SL1 Surface Water Take Application

SOUTHERN LINKS 1
HAMILTON WAIKATO
FOR
SL1 CONSORTIUM GROUP

Fast-Track Pre-Lodgement Consultation Summary

Project name:	Southern Links 1
Engagement type:	Pre-lodgement consultation for substantive application
Applicant/agent:	Applicant: SL1 Consortium Agent: Fraser McNutt (Barker & Associates), [REDACTED]
Proposal overview:	The proposal includes two portions of development: 1. Residential developments across approximately 48 ha of land within the Waipā District along the southern boundary of Hamilton City Council. This is expected to include approximately 1,000 to 1,200 units in varying intensity and style and the development will include associated infrastructure such as roads, wastewater, stormwater and water supply; 2. Industrial development comprising 71 ha of both light industrial and farmland located between Higgins Road and Hamilton Railway line.
Location:	Within the Waipā District, contiguous with Hamilton City Council's southern boundary. See map below:

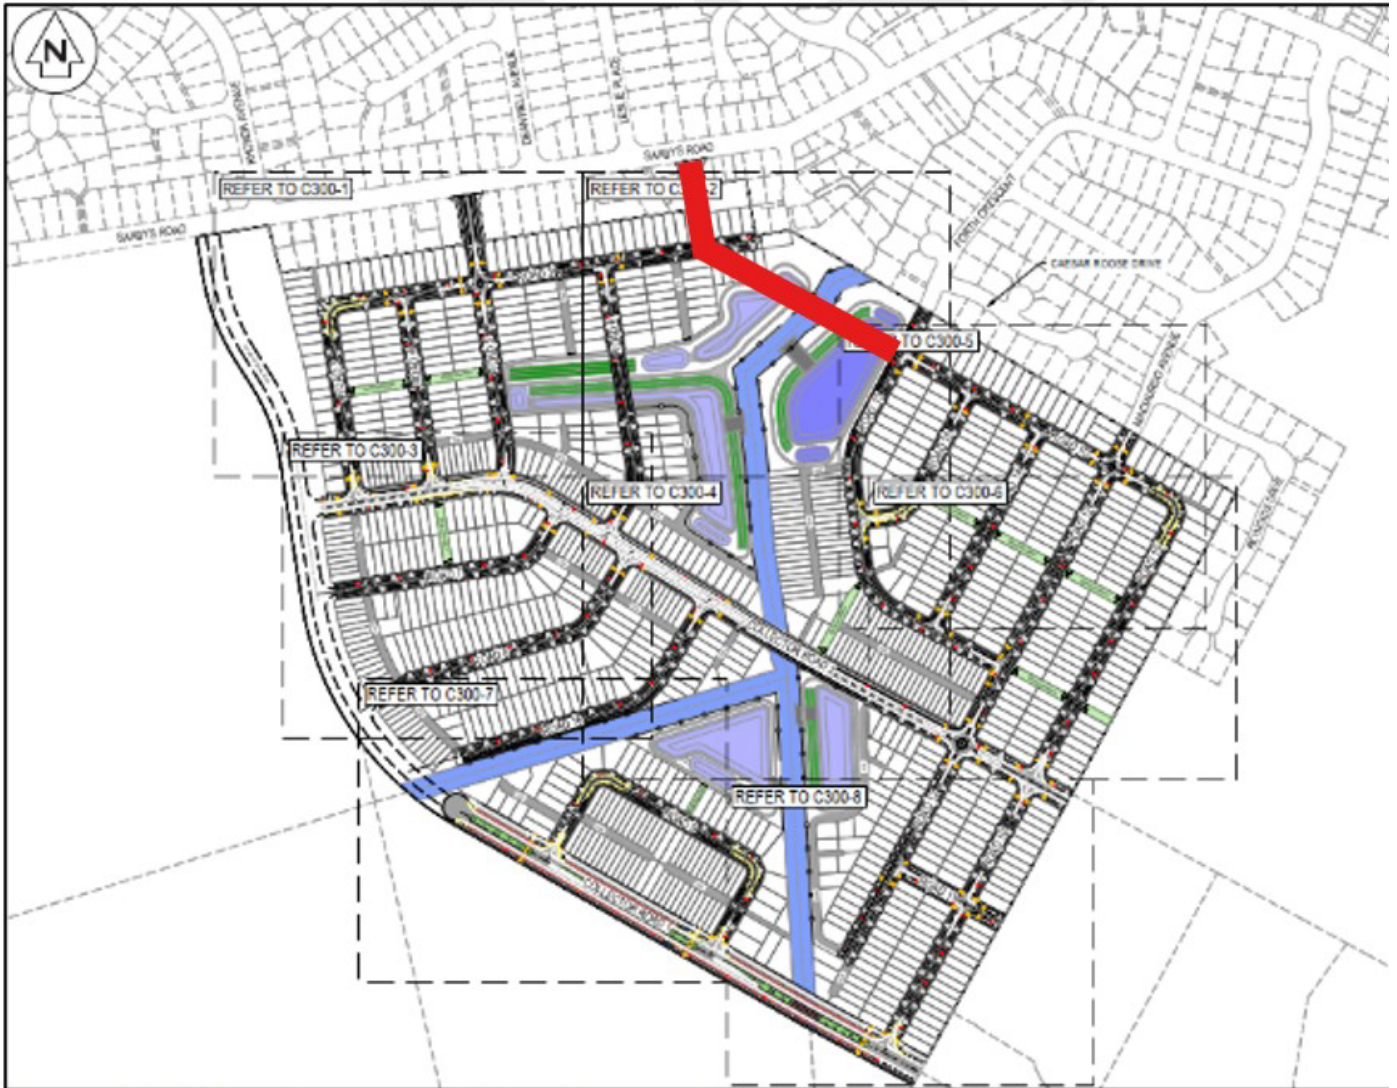
- Guidance provided in Austroads suggests that intersections should be separated by at least five seconds of travel time at the design speed to provide time for drivers to process information.

- The proposed signalised intersection does not appear to cater for cyclists.
- Can the applicant please give consideration to providing another road link from the site to Saxbys Road, so more of the development traffic can use the SH3 Ohaupo Road/Saxbys Road intersection instead of adding additional traffic to the SH3 Ohaupo Road/Lambert Court intersection? Please see red line in the below picture:

Figure 9: SL1 Mexted Residential Development Master Plan

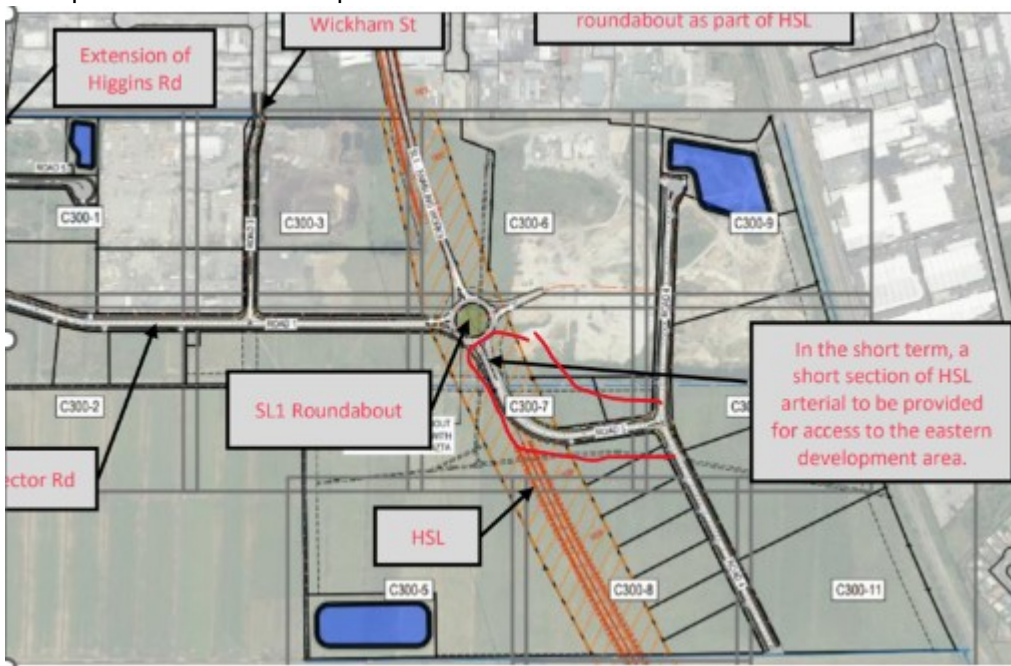
One thing that is of concern is the sacrificial local road section – I am not confident that an agreement will address the consequences of a build up of development on that side and an alternative access to the eastern side being available to the eastern SL1 roundabout stub. The ITA is fairly silent on this and I expect this will form part of our formal response.
